**Memorandum**  
**Department of Planning**

**RE:** **Wildhorse Village, Lot 2A-1 (The Flats at Wildhorse Village) SDSP Modification Request:** A Site Development Section Plan, Landscape Plan, Lighting Plan, Architectural Elevations and Architect’s Statement of Design for a 4.9 acre tract of land located southeast of the intersection of Wild Horse Creek Road and Old Chesterfield Road. (Ward 2)

## Planning Commission Staff Report

<b>Project Type:</b>	Site Development Section Plan
<b>Meeting Date:</b>	August 23, 2021
<b>From:</b>	Mike Knight, Assistant City Planner <i>gmK</i>
<b>Location:</b>	A 4.9 acre tract of land located southeast of the intersection of Wild Horse Creek Road and Old Chesterfield Road.
<b>Description:</b>	<b><u>Wildhorse Village, Lot 2A-1 (The Flats at Wildhorse Village) SDSP:</u></b> A Site Development Section Plan, Landscape Plan, Lighting Plan, Architectural Elevations and Architect's Statement of Design for a 4.9 acre tract of land located southeast of the intersection of Wild Horse Creek Road and Old Chesterfield Road.

Figure 6: Roof Top Units

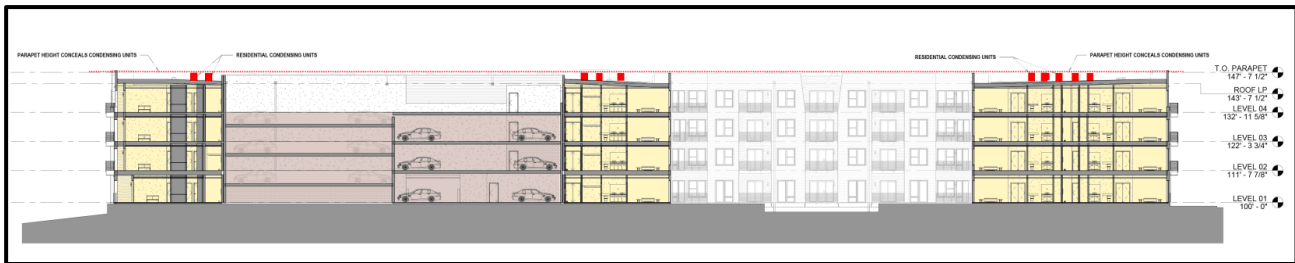
The residential units will be screened by the parapet walls. The applicant has provided a roof-top screening exhibit which is included in the packet. The units will be located above the residential units as depicted in the image below (Figure 6.)

- Provide a color for the rooftop units that is color compatible with the surrounding materials
- Additional handrailings added to address building code compliance should be consistent with the existing railings depicted for the project.
- Provide the decibel levels within the parking garage.
- Evaluate the base of the building and incorporate additional material and/or color to soften the large monochromatic space of the white brick building

- Provide a color for the rooftop units and match with the surrounding rooftop.
  - **Response: Rooftop equipment finish color will be light gray to match the gray roofing membrane.**
- Additional handrailing added to address building code compliance should be consistent with the existing railings depicted for the project.
  - **Response: Final handrail selections will be black anodized aluminum, consistent with the depicted handrails at the balconies.**
- Provide the decibel levels of mechanical equipment within the parking garage.
  - **Response: Estimated decibel level of the fully enclosed mechanical equipment for (8) garage make-up air units (2 per levels 1 through 4) – 50db/each.**
  -
- Evaluate the base of the building and incorporate additional material and/or color to soften the white velour brick of the building.

# Rooftop Screening

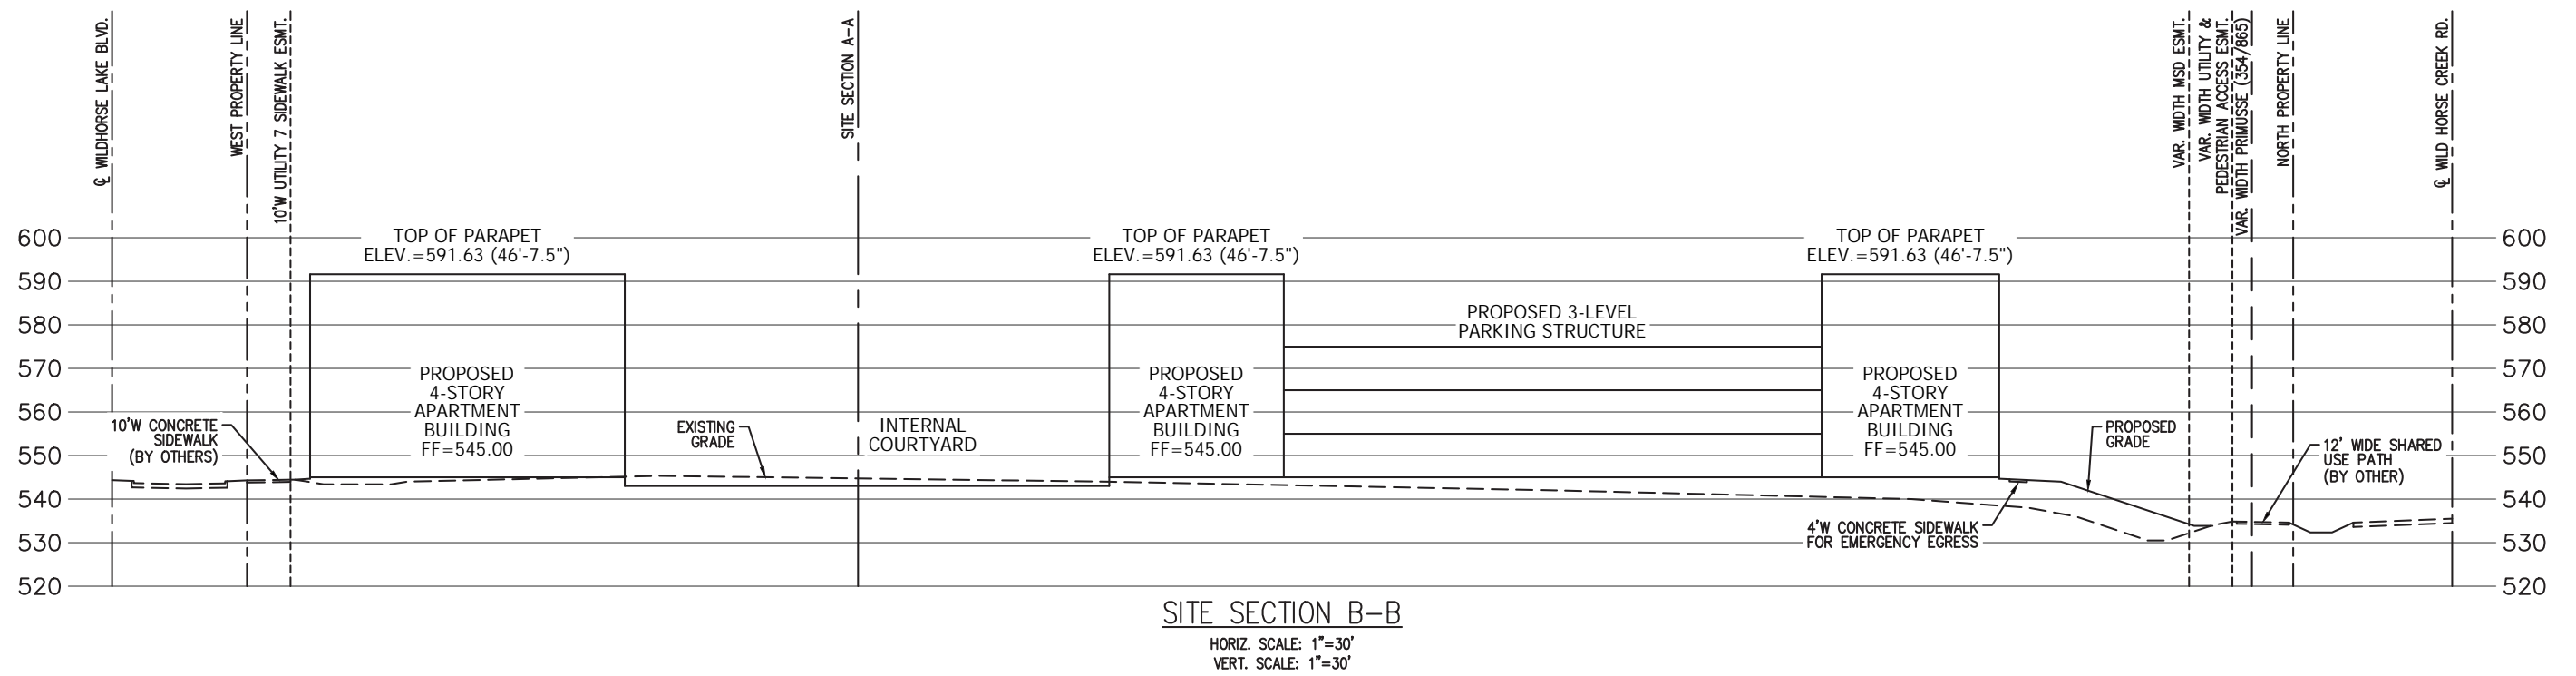
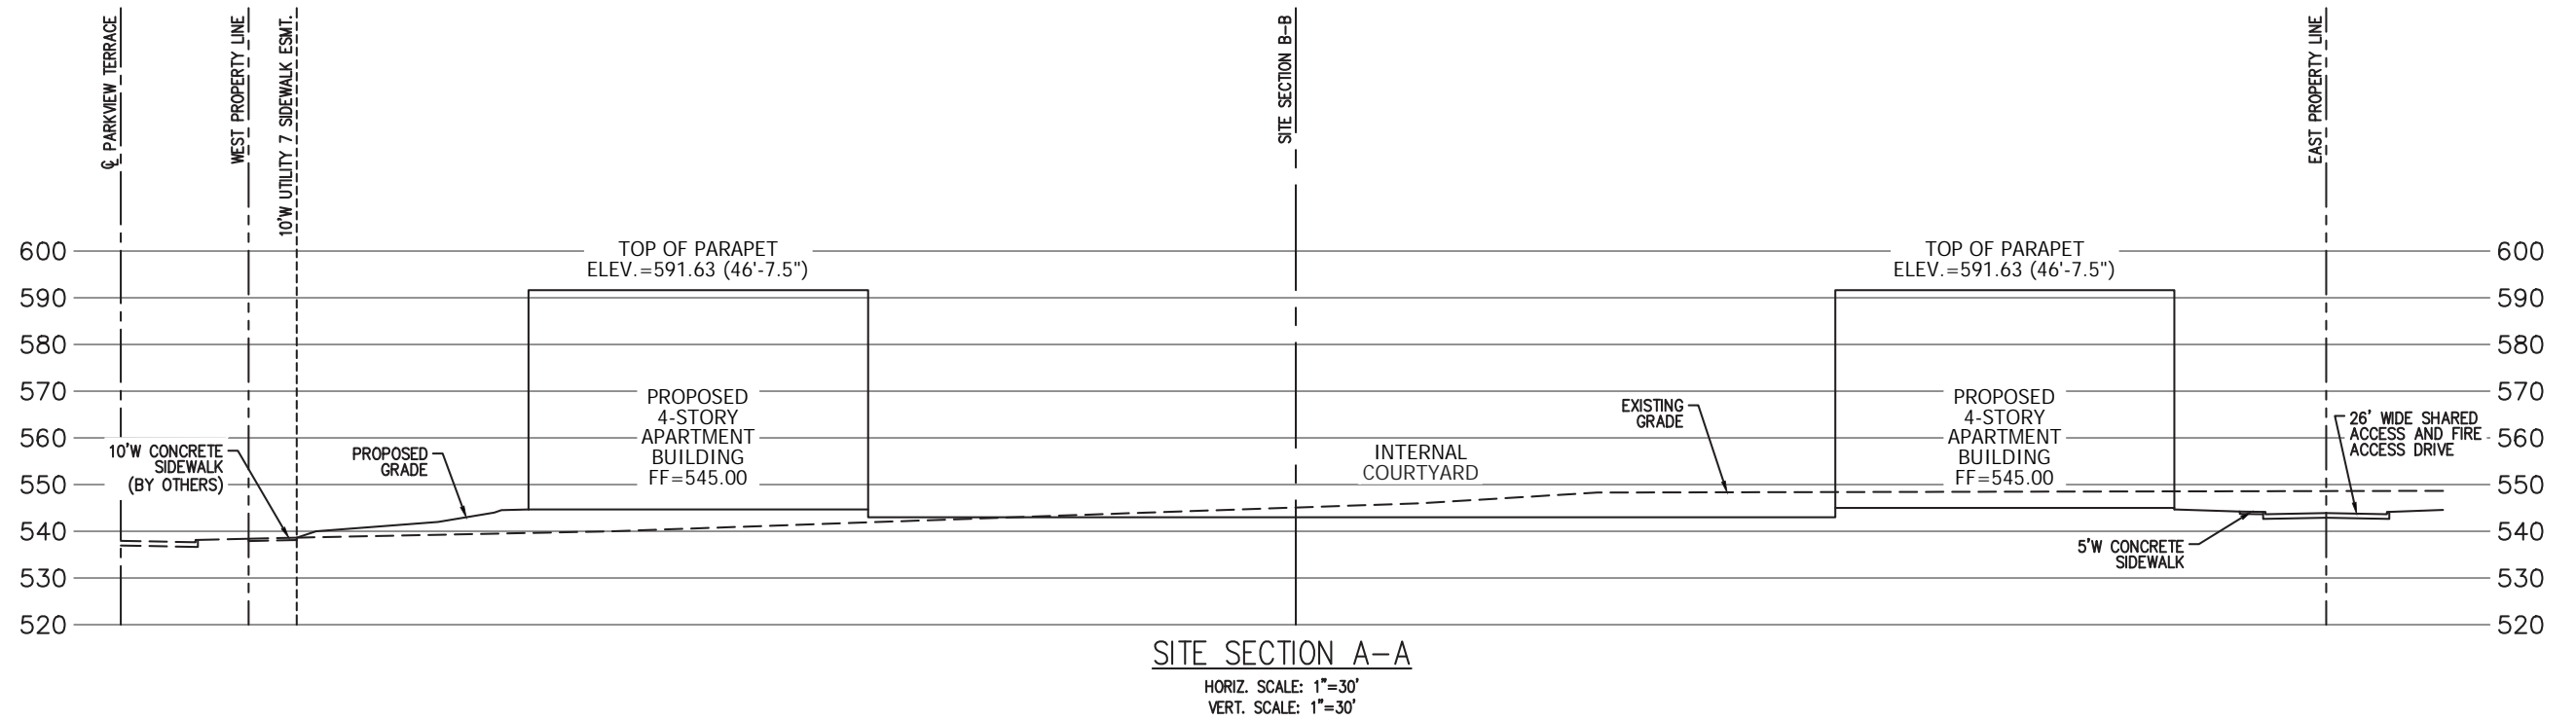
The requested modifications were provided to the Architectural Review Board for review. The Board was supportive of both modification requests. The Board felt that visually the first floor would appear as 12' in height and the additional waste would be unwarranted. In regards to the rooftop mechanical unit screening, the Board felt that the parapet screening was appropriate provided the location within the Wildhorse Village and the specific mechanical units required for a multi-family residential building.

We request a modification to Section IG.5 of Ordinance No. 3114, which states: “rooftop mechanical equipment shall be permitted on roofs within architecturally designed, fully enclosed penthouses that complement the building design.” We are proposing to screen rooftop equipment on all visible sides with materials that are an integral part of the architecture. Parapet walls or screen walls will be treated as an integral part of the architecture and will not visually weaken the design of the structure, per UDC Section 405.04.010.
